PLEASANT VALLEY ROAD / I-77 SB RAMP
/ FORESTWOOD DRIVE INTERSECTION
'BUILD ALTERNATIVE 3'

FIGURE 10
PLEASANT VALLEY ROAD /
INTERSECTION
ALTERNATIVE 5'

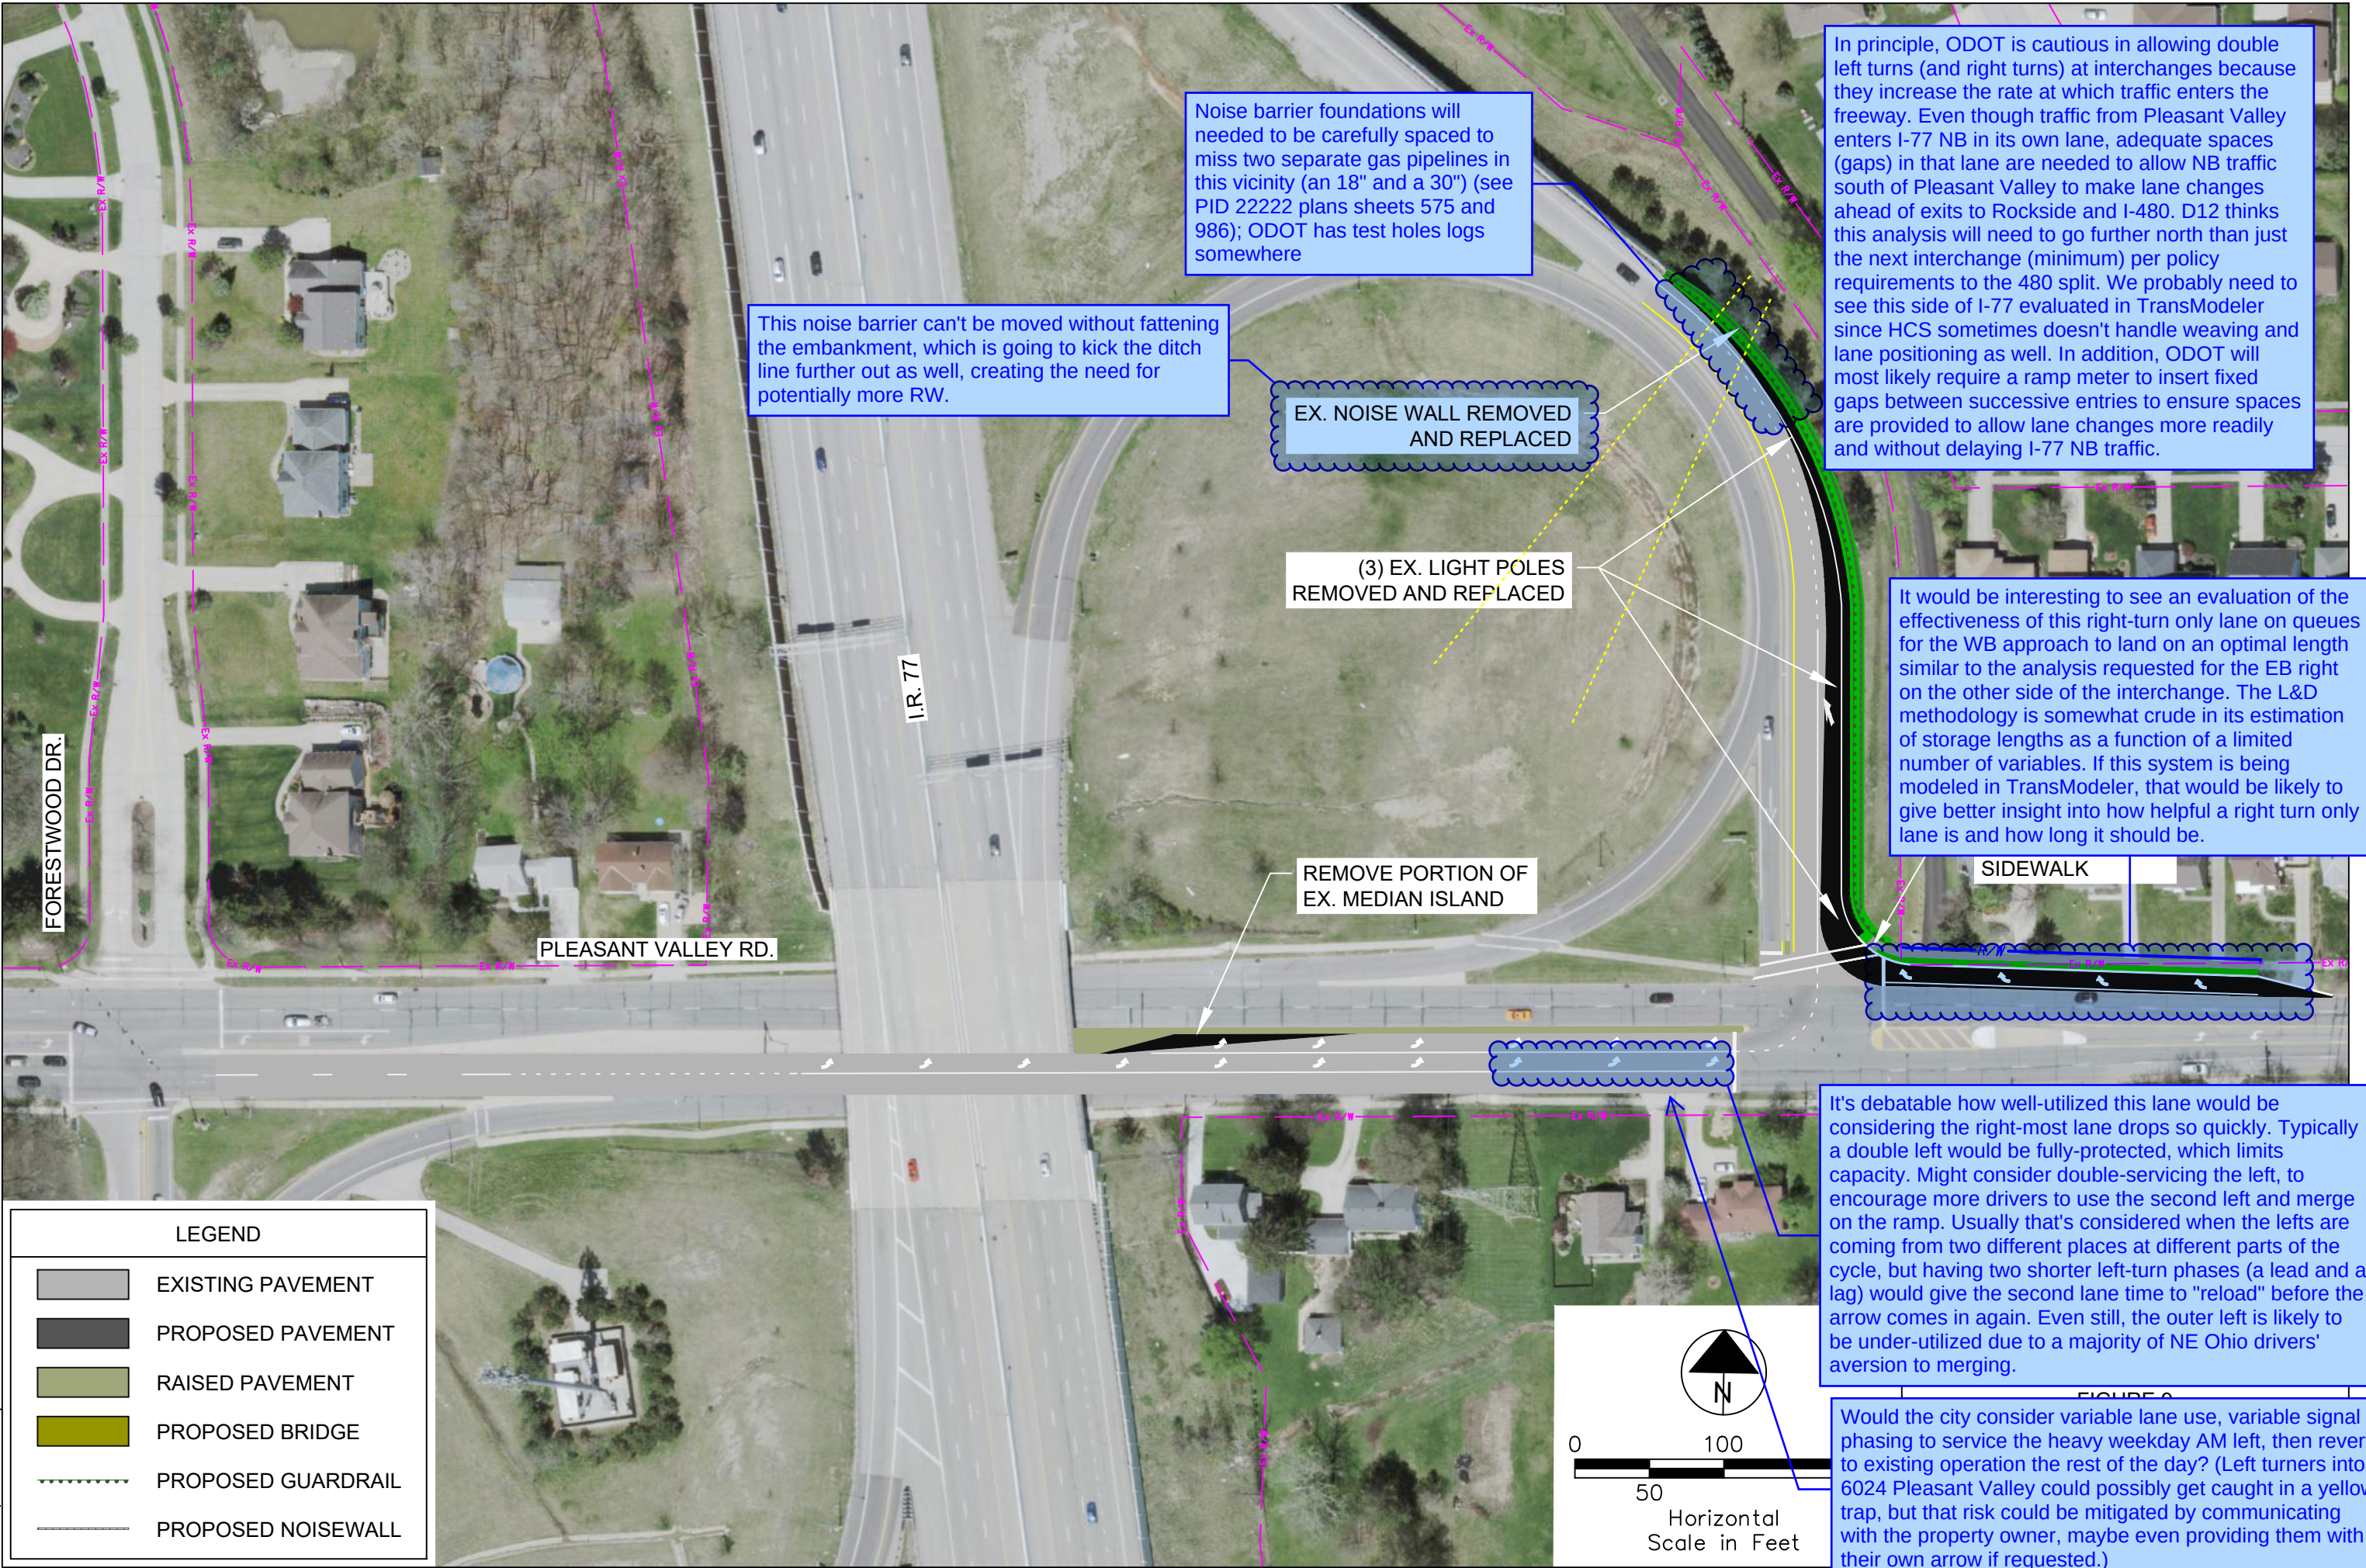
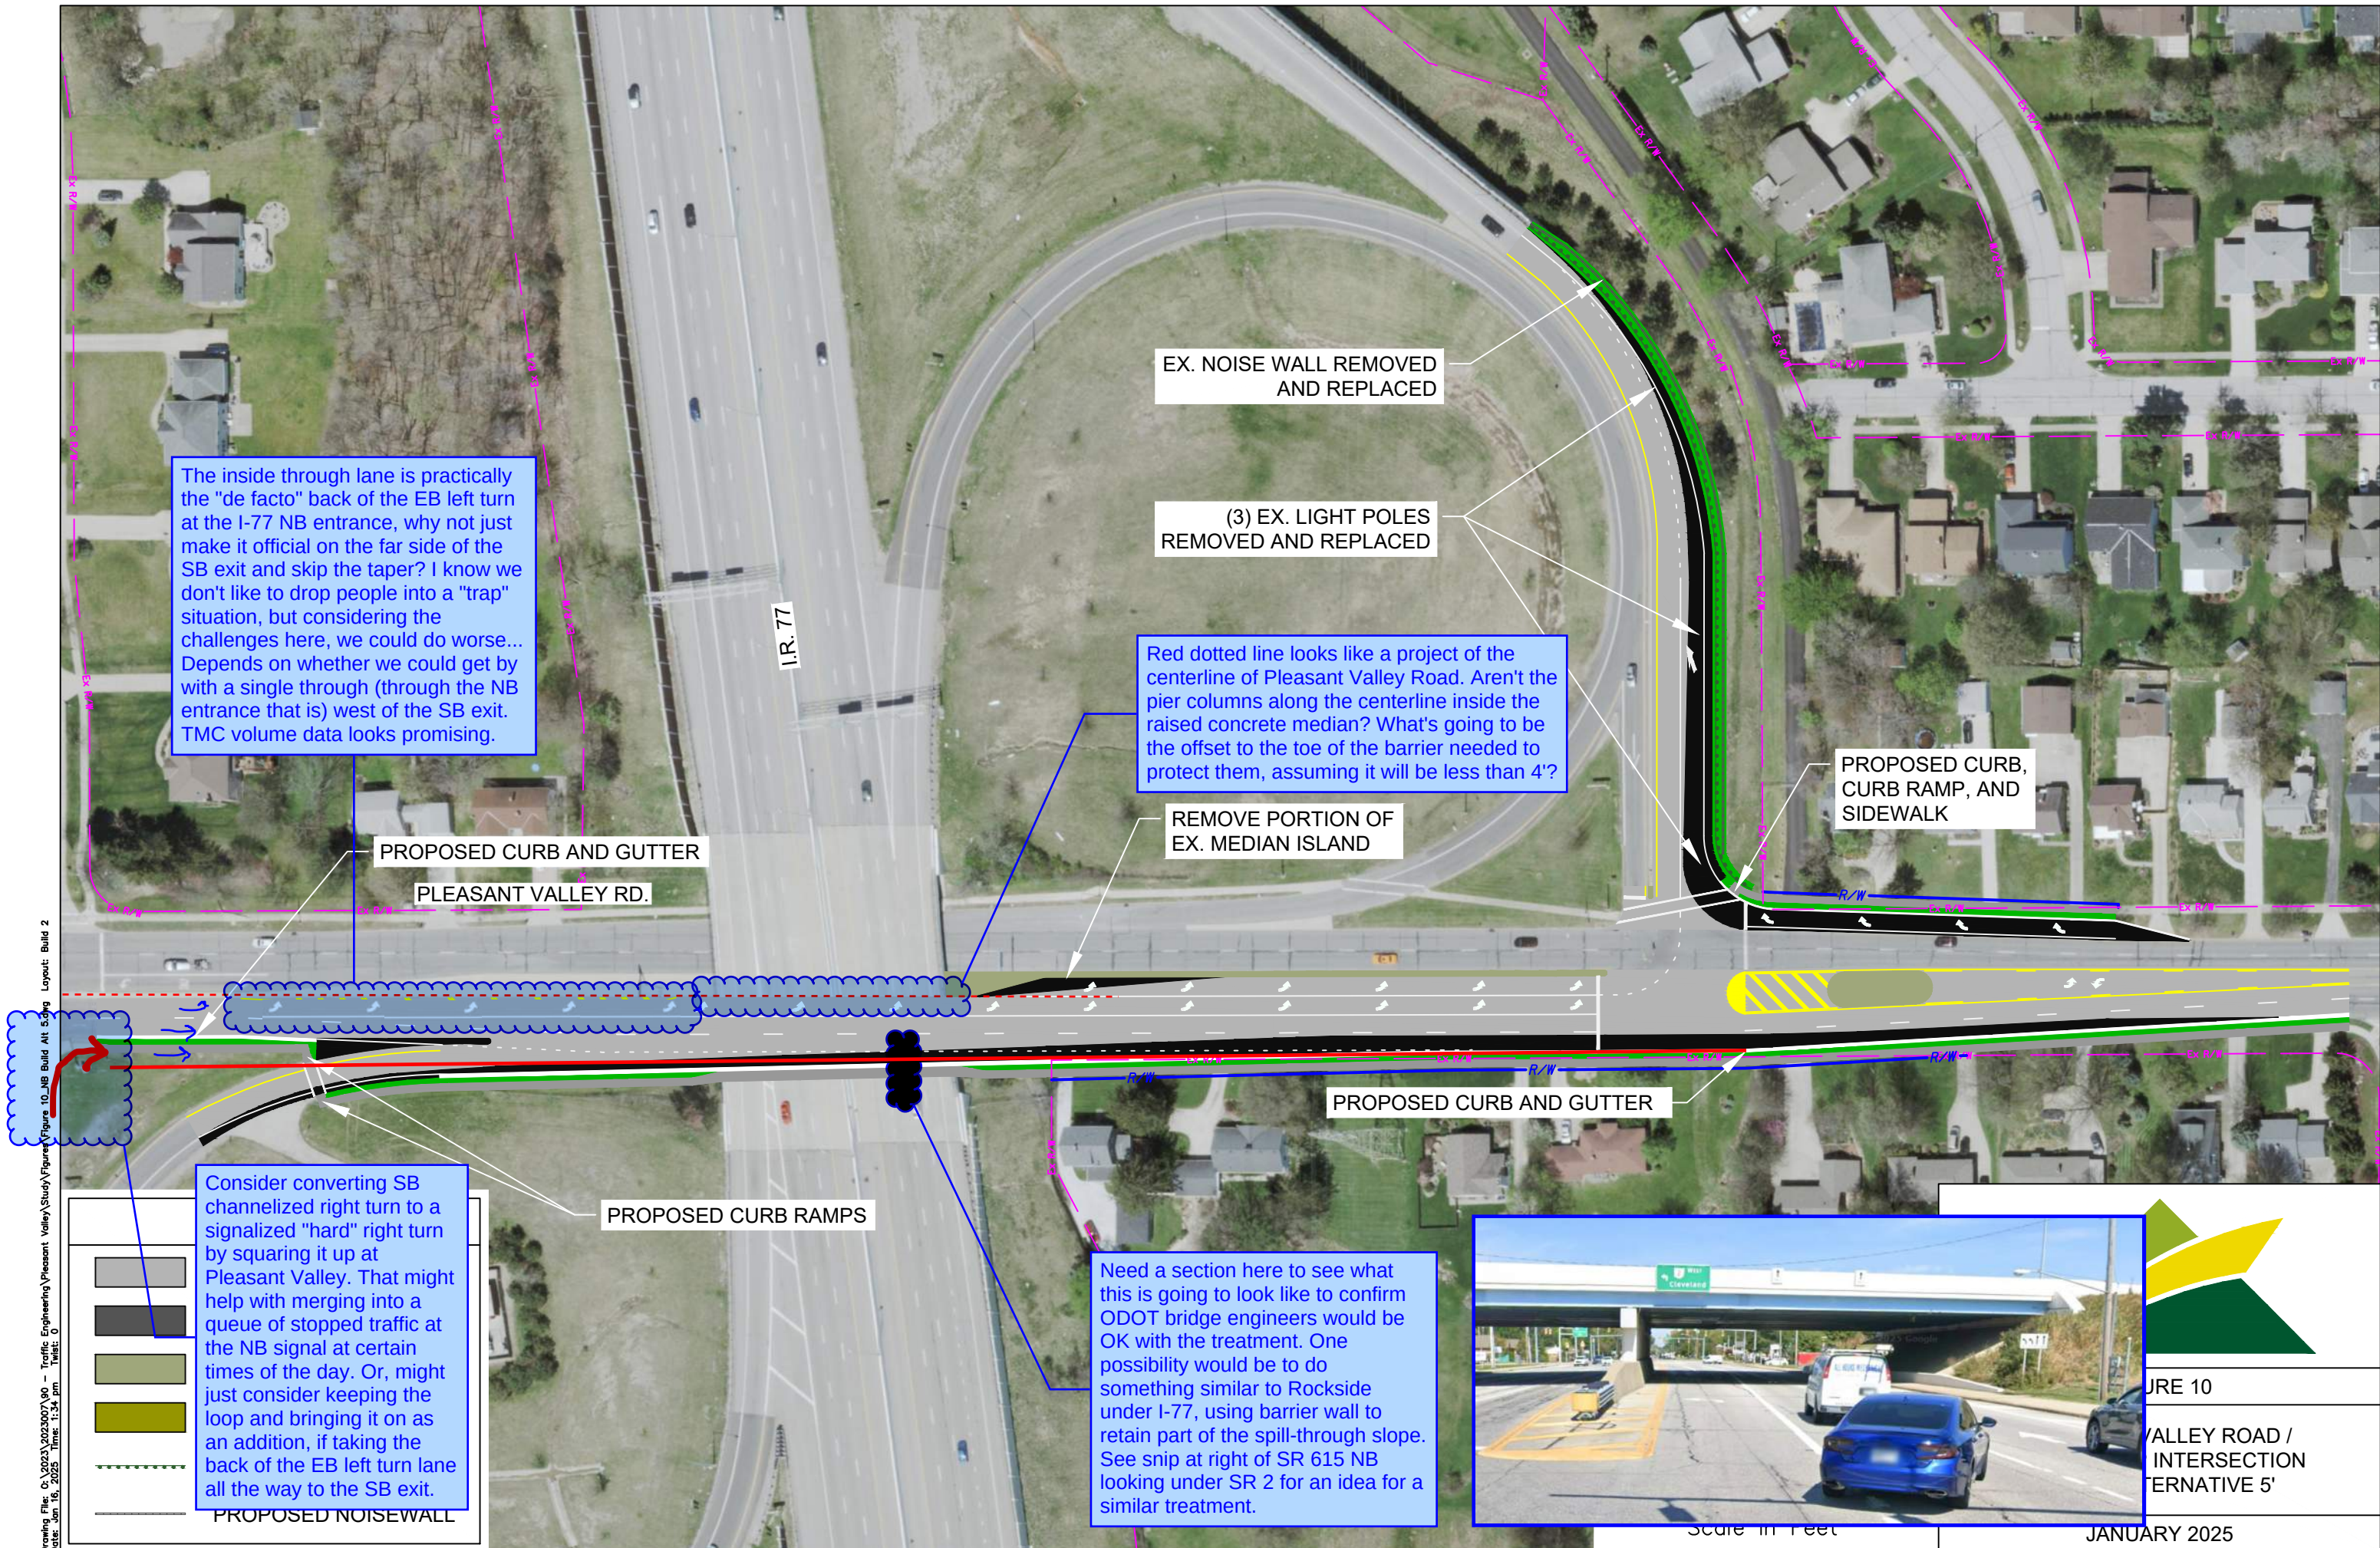
The inside through lane is practically the "de facto" back of the EB left turn at the I-77 NB entrance, why not just make it official on the far side of the SB exit and skip the taper? I know we don't like to drop people into a "trap" situation, but considering the challenges here, we could do worse... Depends on whether we could get by with a single through (through the NB entrance that is) west of the SB exit. TMC volume data looks promising.

Red dotted line looks like a project of the centerline of Pleasant Valley Road. Aren't the pier columns along the centerline inside the raised concrete median? What's going to be the offset to the toe of the barrier needed to protect them, assuming it will be less than 4'?

Consider converting SB channelized right turn to a signalized "hard" right turn by squaring it up at Pleasant Valley. That might help with merging into a queue of stopped traffic at the NB signal at certain times of the day. Or, might just consider keeping the loop and bringing it on as an addition, if taking the back of the EB left turn lane all the way to the SB exit.

Need a section here to see what this is going to look like to confirm ODOT bridge engineers would be OK with the treatment. One possibility would be to do something similar to Rockside under I-77, using barrier wall to retain part of the spill-through slope. See snip at right of SR 615 NB looking under SR 2 for an idea for a similar treatment.
